Intersection ID: 10027019	Main Street: FREELAND_LN	Cross Street: N/A	Location:	NW
ADA ID: 931FD90A2A42	Ramp Type: PerpDiag	Initial Pass/Fail: Fail	Overall Compliance: No	Severity Score: 46.25

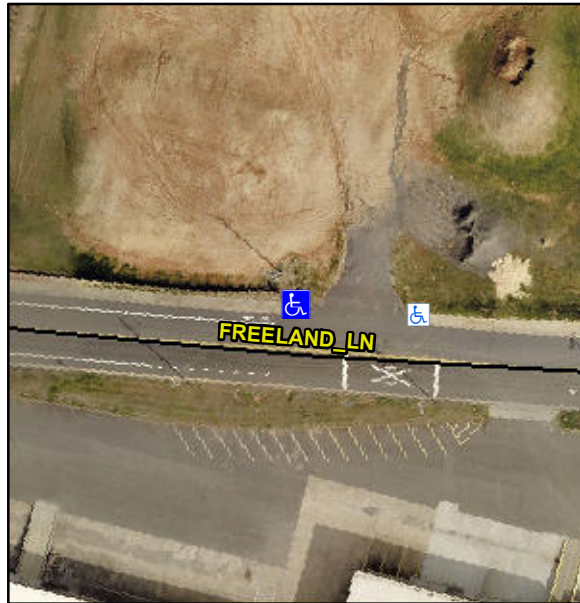
**Not Found, R304.5.1, R304.2.2,
R304.5.3**

Compliance	Description	Data	Compliance	Description	Data
N/A	Ramp Length (in)	32.0	No	Ramp Slope (%)	10.7
No	Ramp Width (in)	46.0	No	Ramp XSlope (%)	8.7
N/A	Flare Type LT	N/A	N/A	Flare Type RT	N/A
N/A	Flare Slope LT (%)	N/A	N/A	Flare Slope RT (%)	N/A
N/A	Flare Traversable LT?	N/A	N/A	Flare Traversable RT?	N/A
N/A	Landing Length (in)	N/A	N/A	DWS Provided?	N/A
N/A	Landing Width (in)	N/A	N/A	DWS Contrast?	N/A
N/A	Landing Slope (%)	N/A	N/A	DWS Length (in)	N/A
N/A	Landing X Slope (%)	N/A	N/A	DWS Full Width?	N/A
N/A	Landing Curb? (Y/N)	N/A	N/A	DWS Offset (in)	N/A
N/A	Shared Landing?	N/A			
N/A	Gutter Ponding?	N/A	N/A	Gutter Slope (%)	N/A
N/A	Gutter Lip Ht (in)	N/A	N/A	Gutter X Slope (%)	N/A
N/A	Painted X Walk1?	No	N/A	Painted X Walk2?	No
	X Walk 1 Direction	To S		X Walk 2 Direction	To E
N/A	X Walk 1 Width (in)	N/A	N/A	X Walk 2 Width (in)	N/A
	X Walk 1 Slope (%)	5.6		X Walk 2 Slope (%)	5.3
	X Walk 1 X Slope (%)	2.6		X Walk 2 X Slope (%)	9.8

Remove & Replace Curb Ramp With Two New Directional Ramps or Equivalent.
